Second Revision No. 5032-NFPA 72-2020 [Section No. 3.3.252]

Committee: SIG-PRO

Figure A.12.3.6(1)(a) Class N Pathway Block Diagram – Example 1.

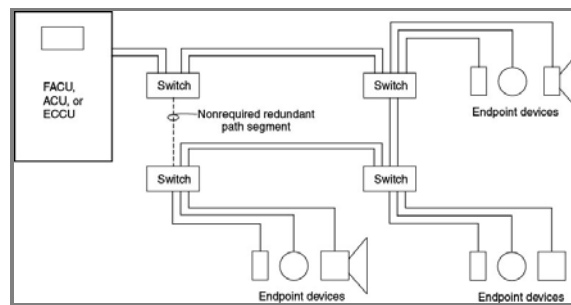
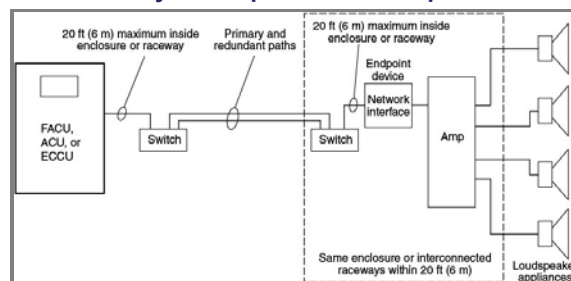
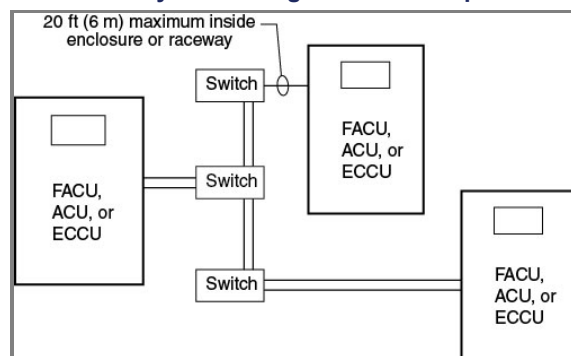
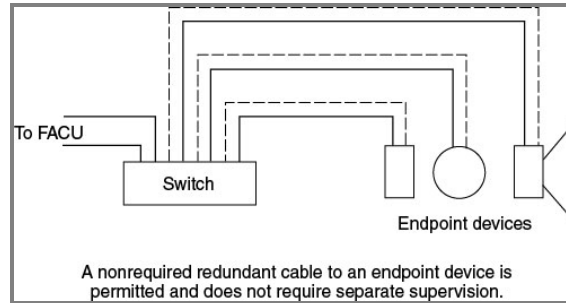
The Class N pathway designation is added to specifically address the use of modern network infrastructure when used in fire alarm and ~~emergency communication or signaling~~ systems.

Redundant pathways, isolated from ground, are actually common practice in robust Ethernet designs. Managed network switches commonly have specific uplink ports that are intended for load sharing and allow two parallel connections. For compliance with Class N, a trouble must be reported if either of these connections fails. [See Figure A.12.3.6(1)(a) and Figure A.12.3.6(1)(b).]

Committee Statement: The Technical Committee accepts direction from the Correlating Committee and revises the text changing “and” to “or” in the 1st paragraph. The TC also changes emergency communication to signaling for consistency throughout the Code. The Technical Committee edits the text to establish consistency throughout the document for the term fiber optics.
